# Access Compliance Report

## Public Rights-of-Way

### (Curb Ramps)

Intersection ID: 43751	Main Street: POTTERS_GLEN_RD	Cross Street: RAKU_CT	Location: SE
ADA ID: AB4AEBECBA87	Ramp Type: Perp	Initial Pass/Fail: Fail	Overall Compliance: No
Severity Score: 33.75			
Codes/Mitigation Info/Possible Solution		Field Measurements/Component Compliance

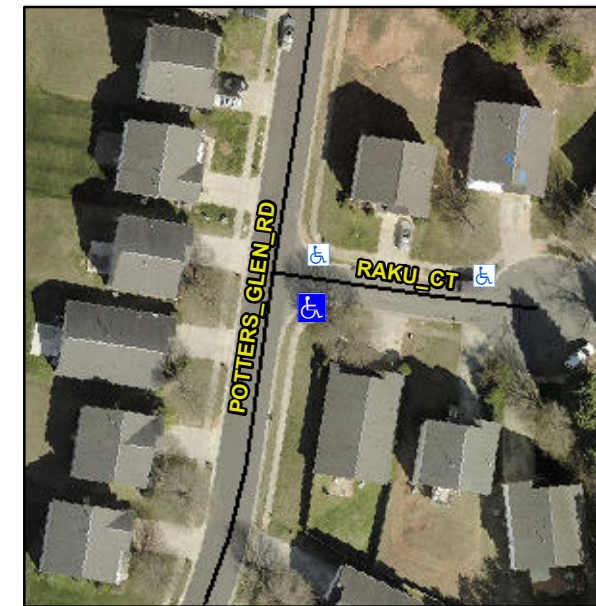
**R304.5.1, R304.2.2, R304.5.3**

Compliance	Description	Data	Compliance	Description	Data
N/A	Ramp Length (in)	47.5	No	Ramp Slope (%)	9.1
No	Ramp Width (in)	40.5	No	Ramp XSlope (%)	5.4
N/A	Flare Type LT	N/A	N/A	Flare Type RT	N/A
N/A	Flare Slope LT (%)	N/A	N/A	Flare Slope RT (%)	N/A
N/A	Flare Traversable LT?	N/A	N/A	Flare Traversable RT?	N/A
N/A	Landing Length (in)	N/A	N/A	DWS Provided?	N/A
N/A	Landing Width (in)	N/A	N/A	DWS Contrast?	N/A
N/A	Landing Slope (%)	N/A	N/A	DWS Length (in)	N/A
N/A	Landing X Slope (%)	N/A	N/A	DWS Full Width?	N/A
N/A	Landing Curb? (Y/N)	N/A	N/A	DWS Offset (in)	N/A
N/A	Shared Landing?	N/A			
N/A	Gutter Ponding?	N/A	N/A	Gutter Slope (%)	N/A
N/A	Gutter Lip Ht (in)	N/A	N/A	Gutter X Slope (%)	N/A
N/A	Painted X Walk1?	No	N/A	Painted X Walk2?	N/A
	X Walk 1 Direction	To N		X Walk 2 Direction	N/A
N/A	X Walk 1 Width (in)	N/A	N/A	X Walk 2 Width (in)	N/A
	X Walk 1 Slope (%)	3.3		X Walk 2 Slope (%)	N/A
	X Walk 1 X Slope (%)	3.8		X Walk 2 X Slope (%)	N/A

**Remove & Replace Entire Ramp.**
